ADDENDUM NO. 1

April 14, 2022

YOST ELEMENTARY SCHOOL ADDITIONS AND RENOVATIONS Chesterton, IN 46304

Addendum One (AD.01) to the drawings and specifications prepared by Gibraltar Design for **New Yost Elementary School** for Duneland School Corporation, Chesterton, Indiana.

| D | EL104 |

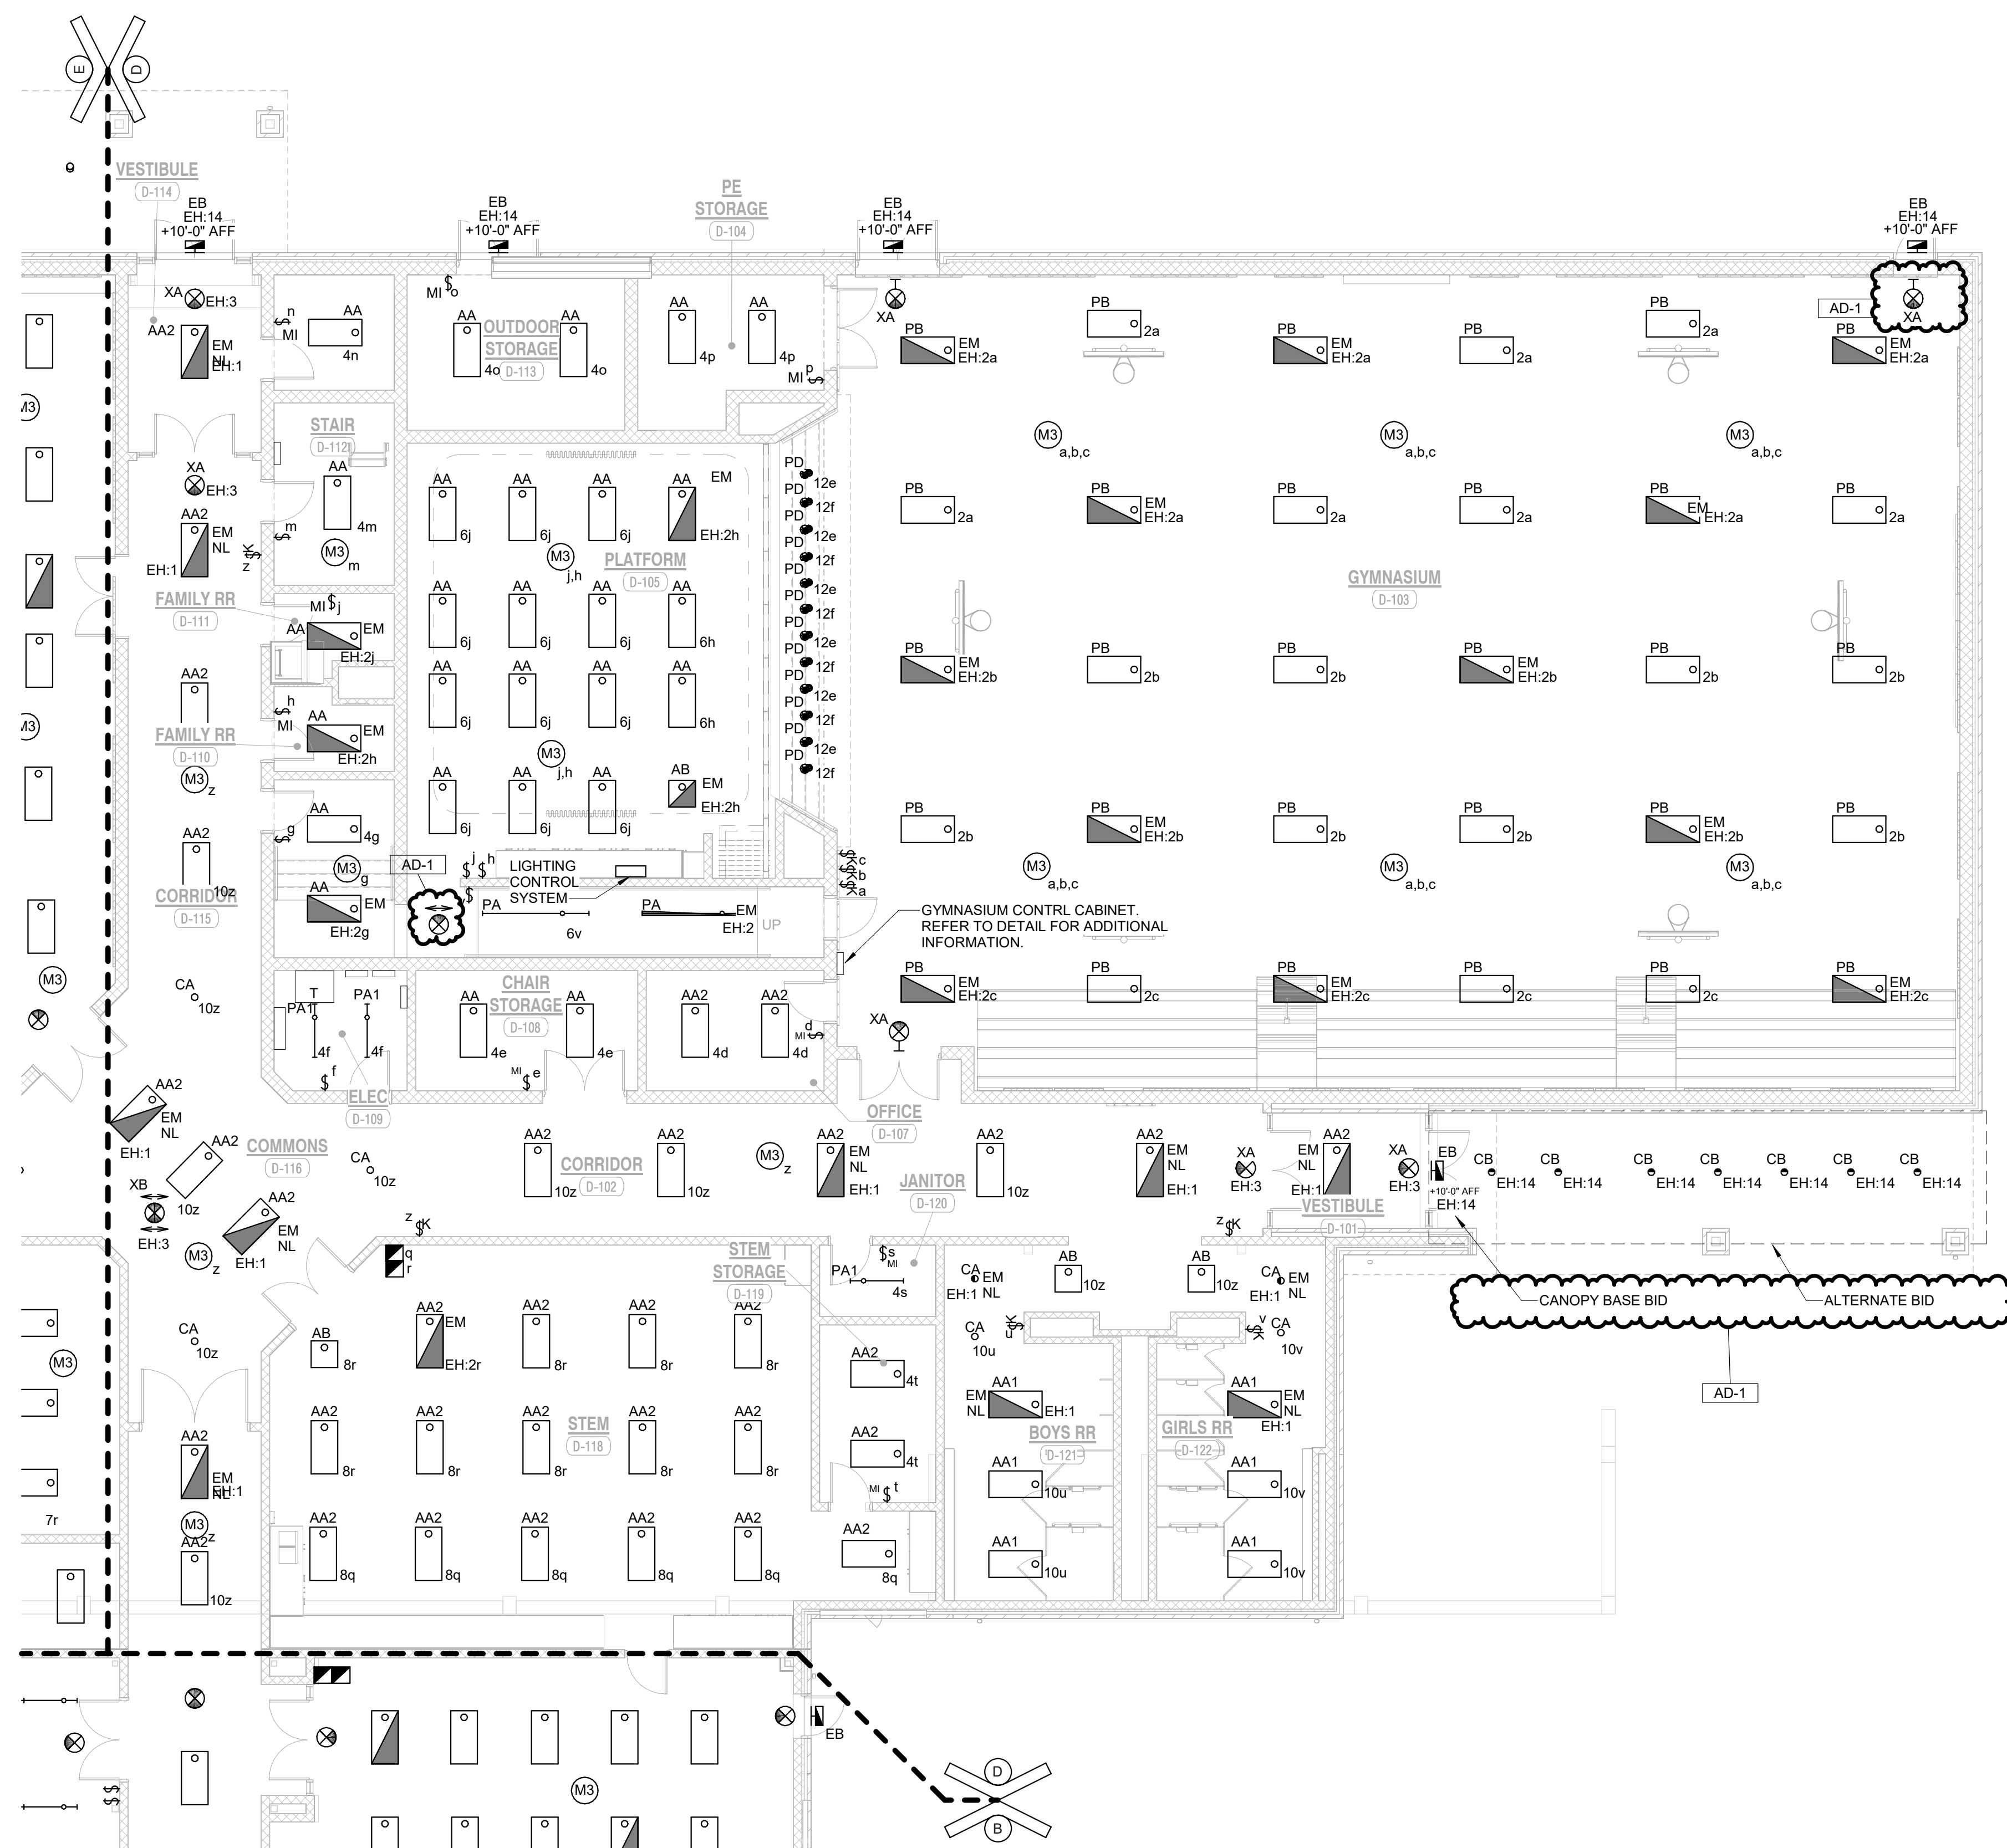
46. Sheet EL104

- A. Refer to revised full size drawing, included in this Addendum, for the following revisions:
 - 1. Added exit sign to Platform D-105.
 - 2. Added exit sign to (1) additional gym exit Door D-103.
 - 3. Clarify Base Bid vs. Alternate bid lighting at Canopy Entrance D-101.

EL105

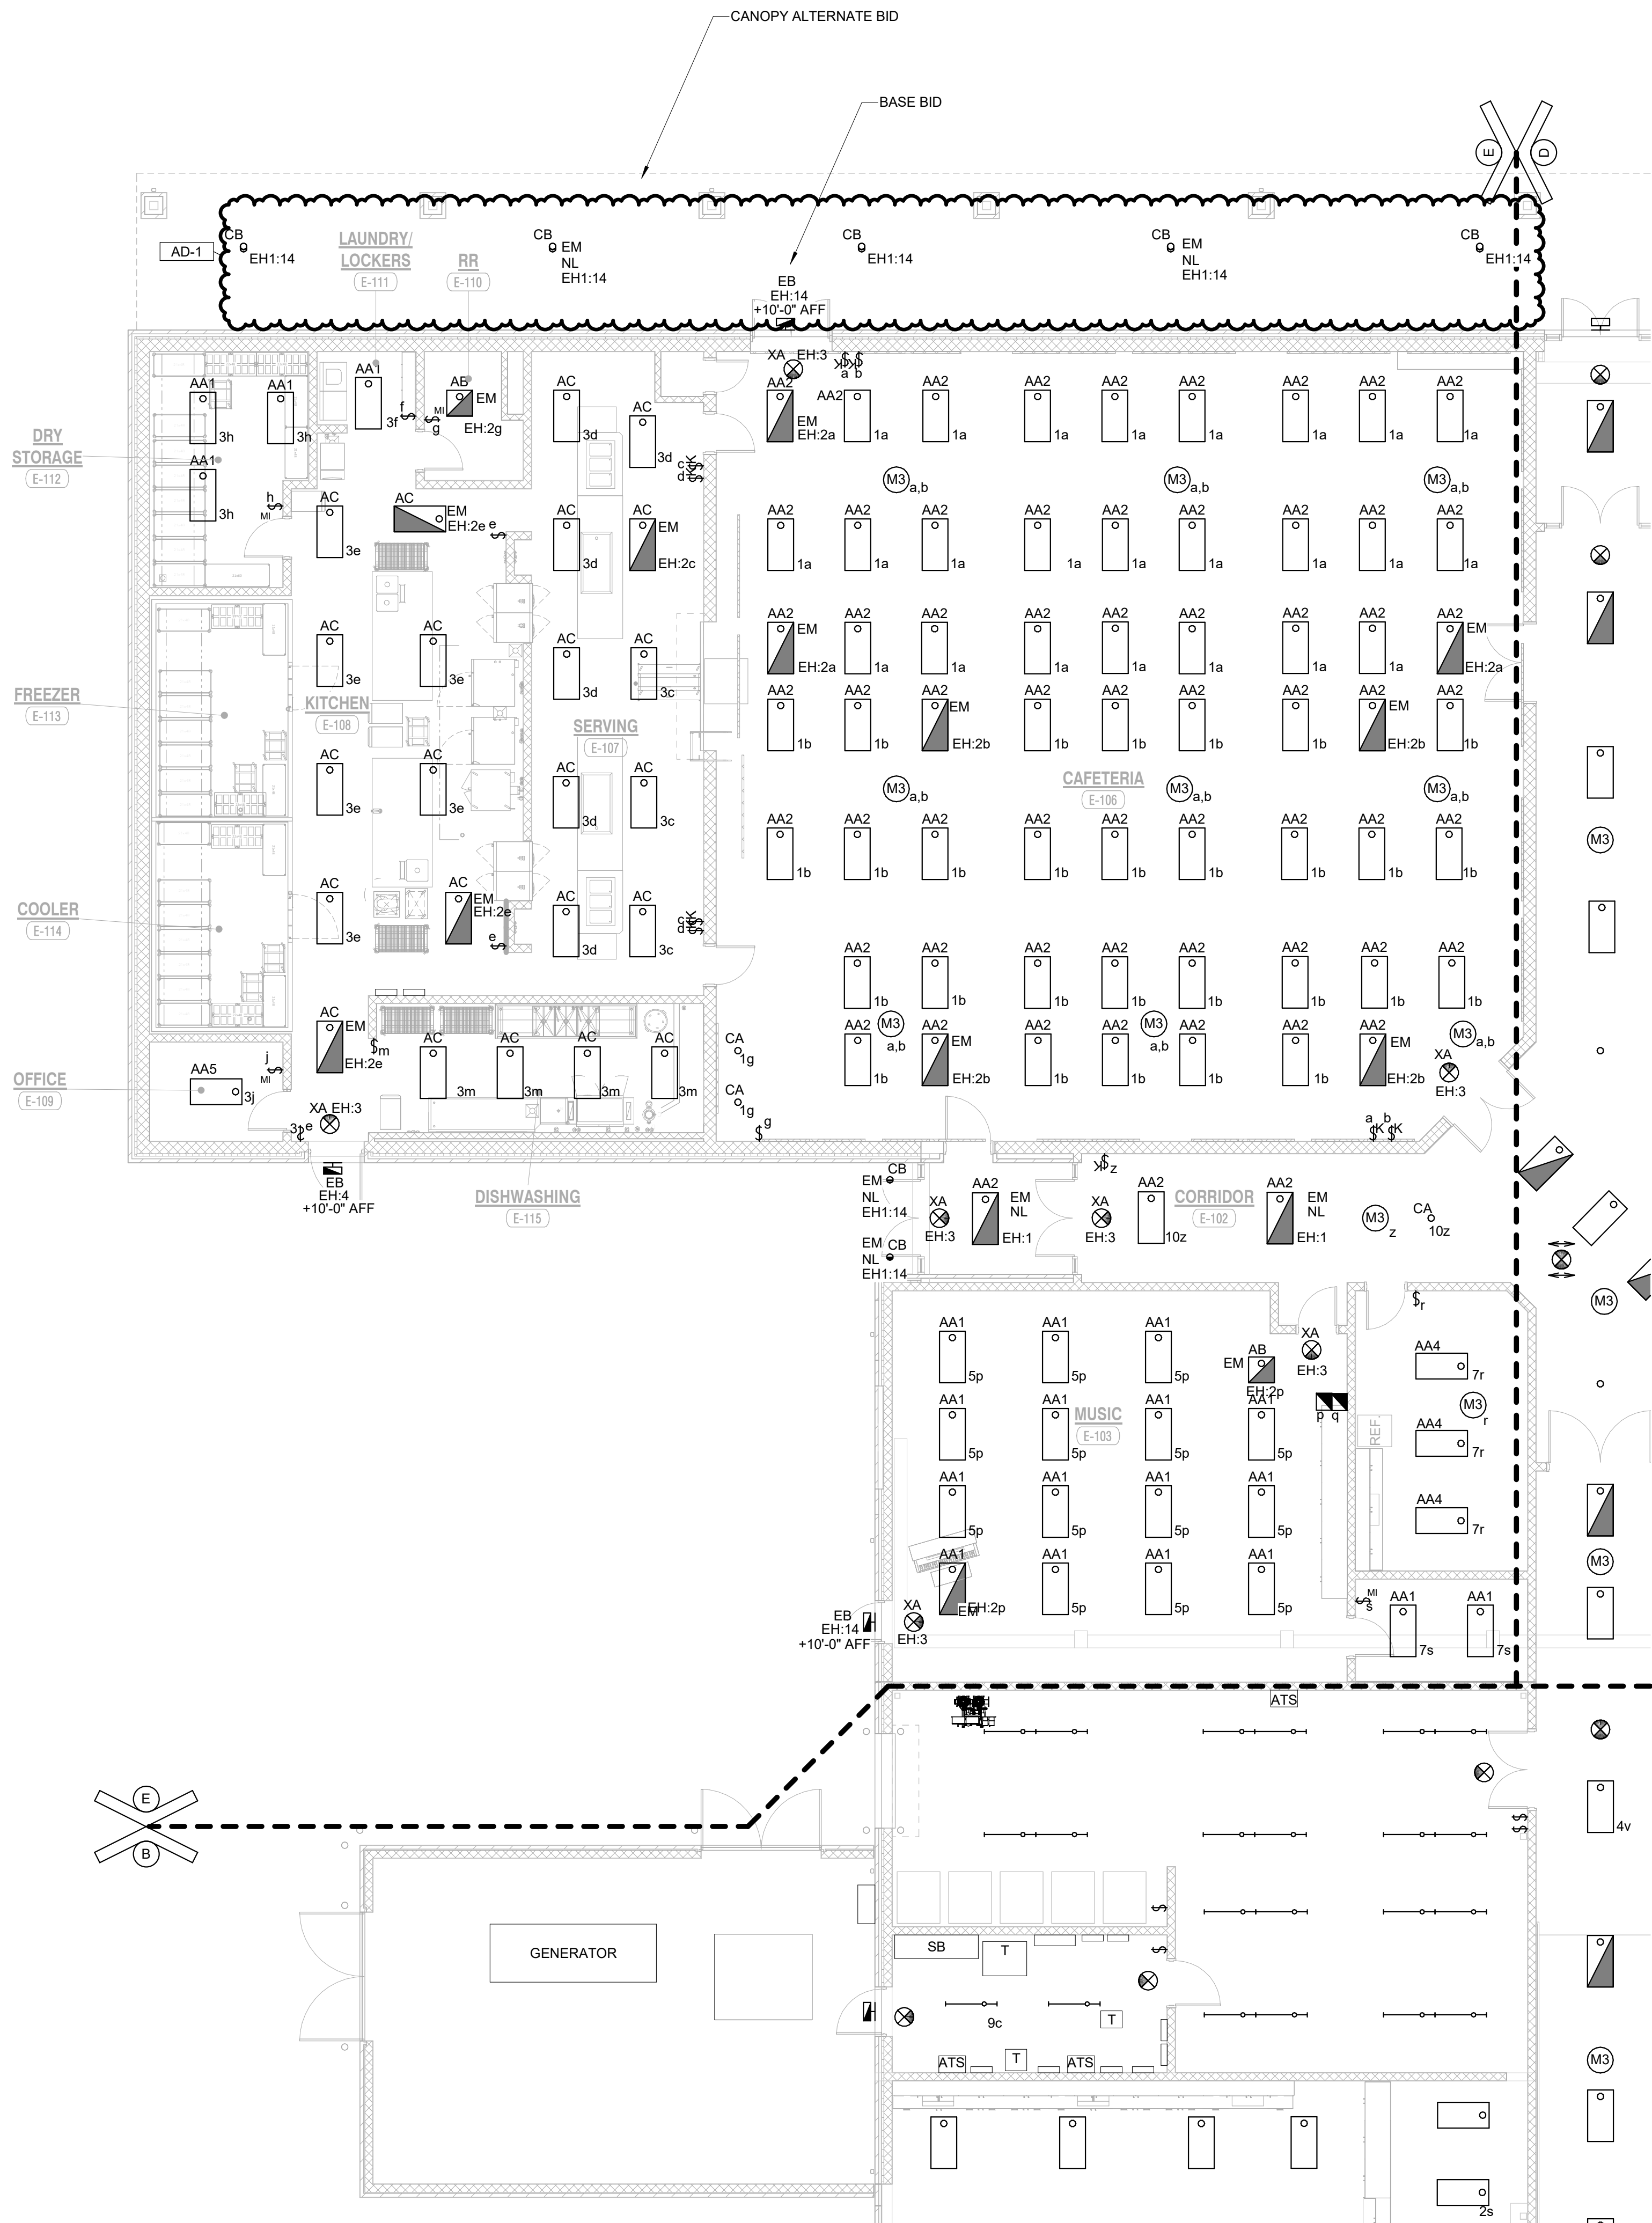
47. Sheet EL105

- A. Refer to revised full size drawing, included in this Addendum, for added downlights at northern canopy.

1
EP107

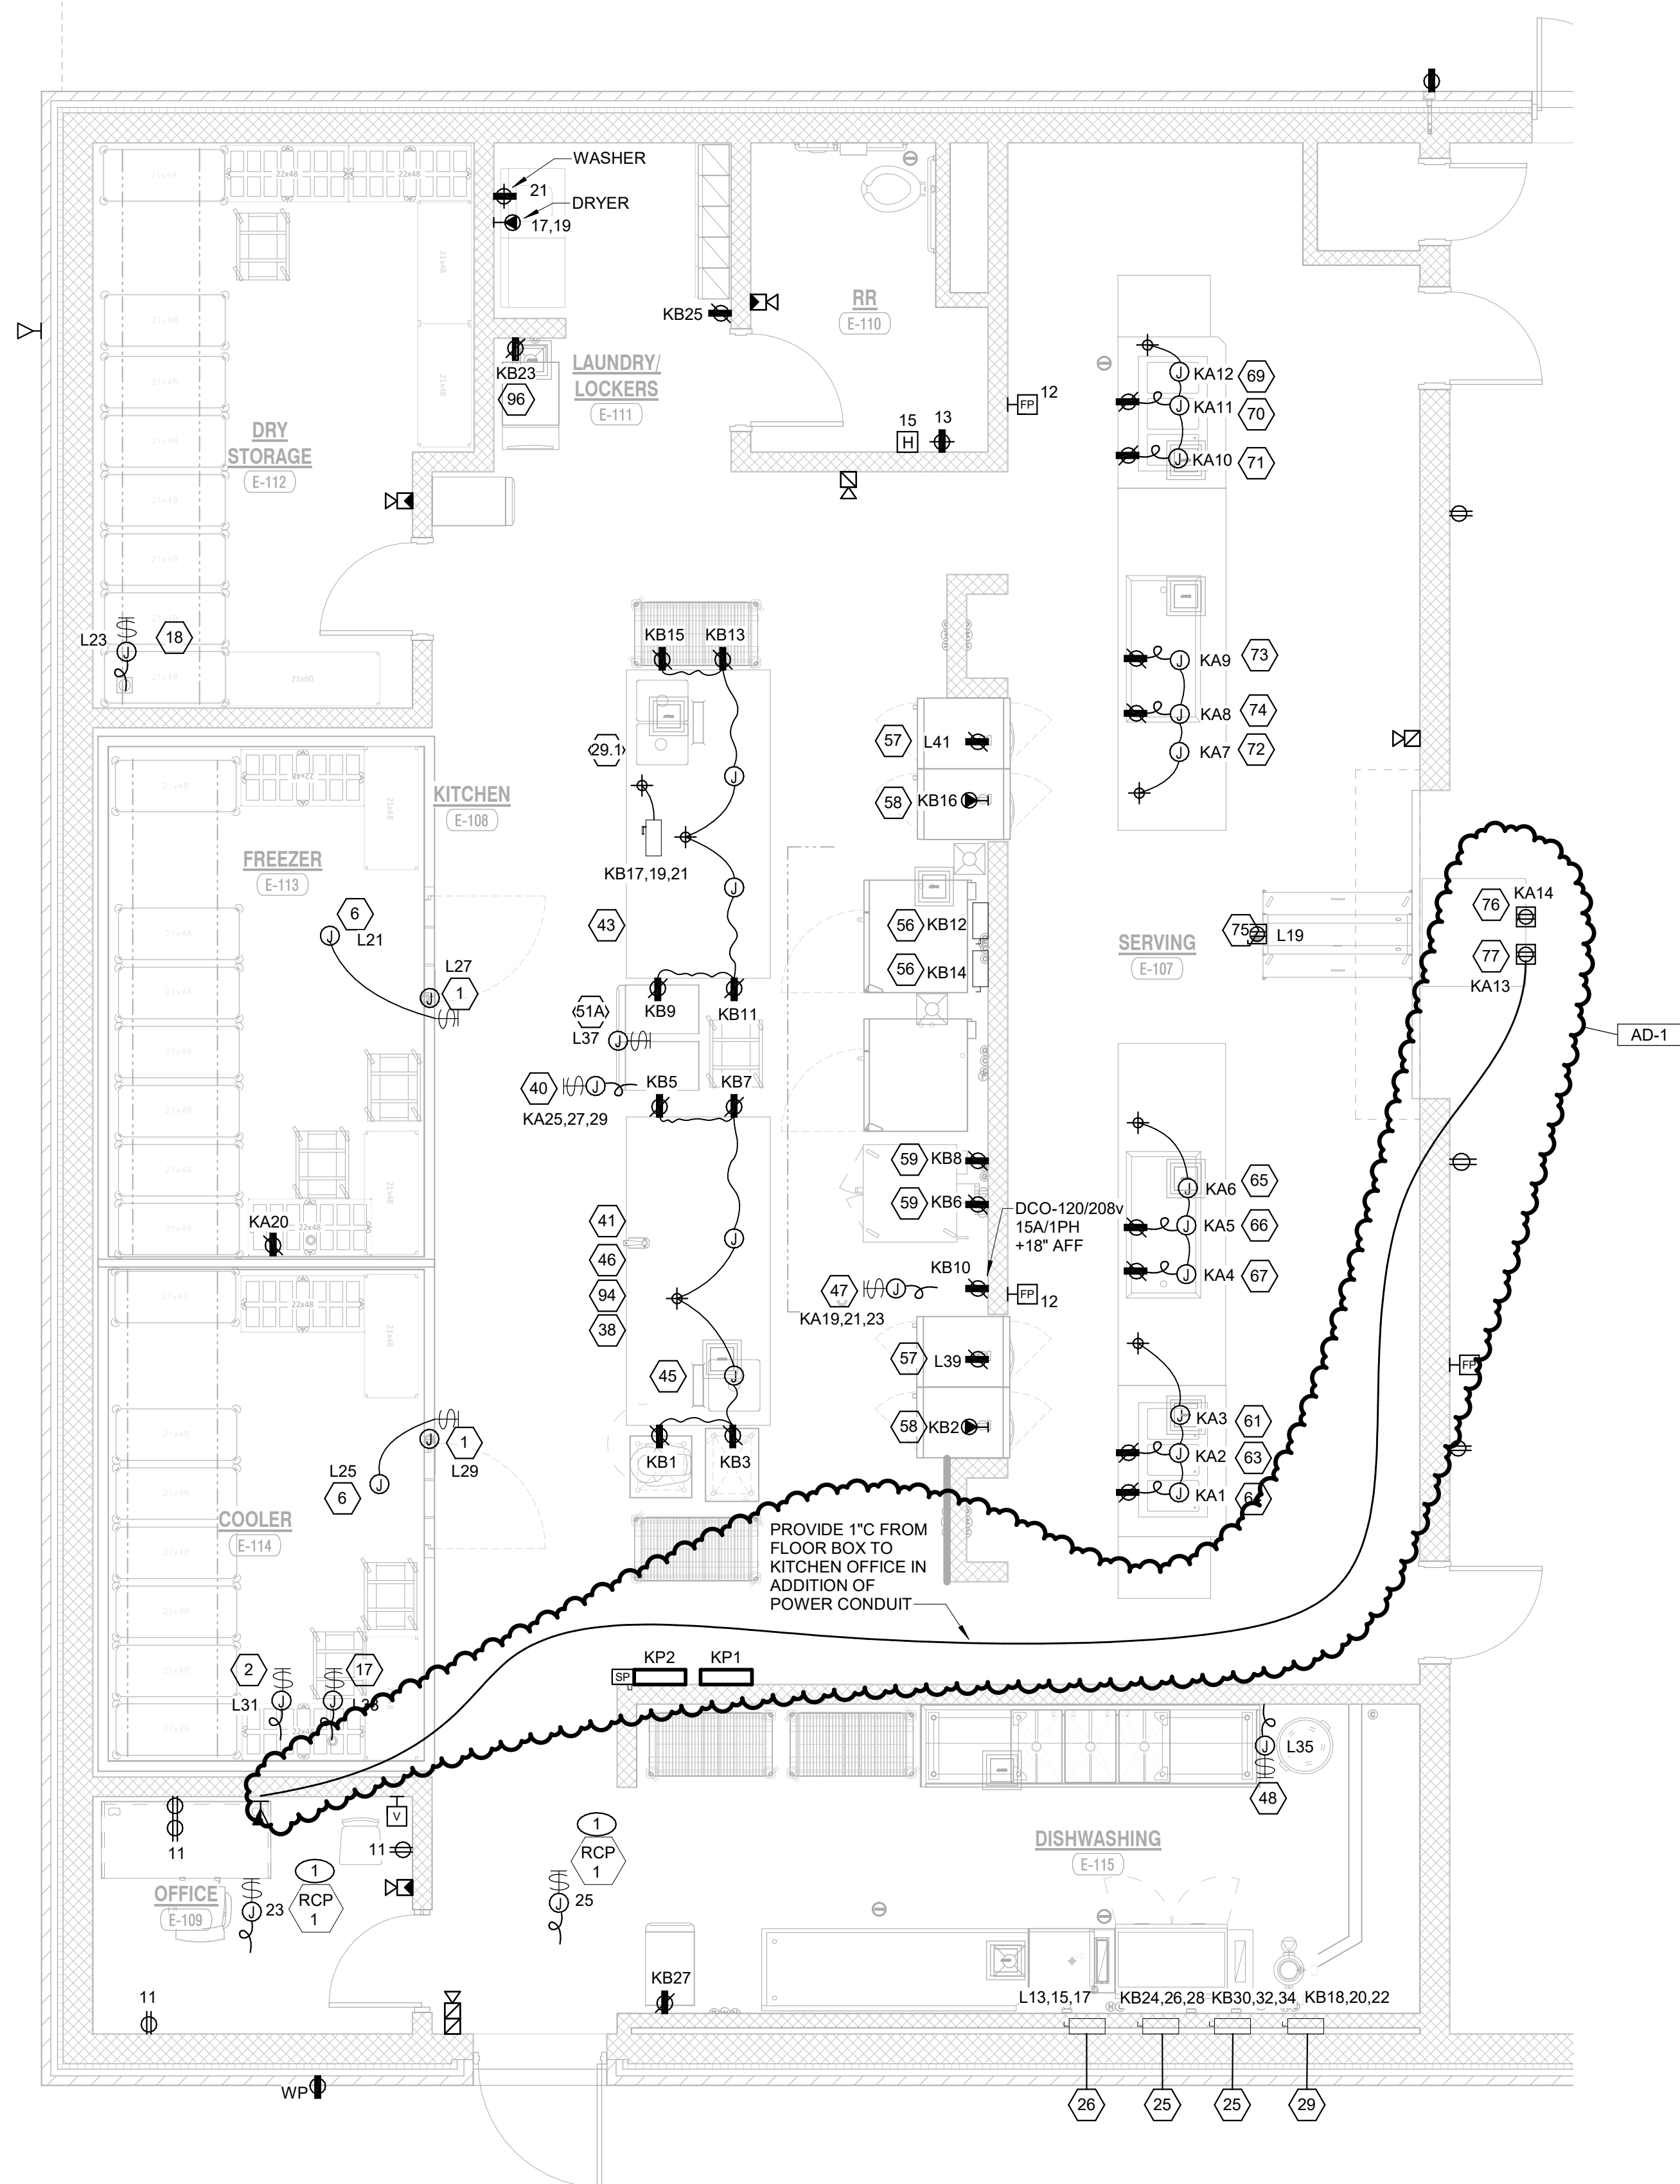
53. Sheet EP107

- A. Refer to revised full size drawing, included in this Addendum, for added 1" conduit in Kitchen E-108.
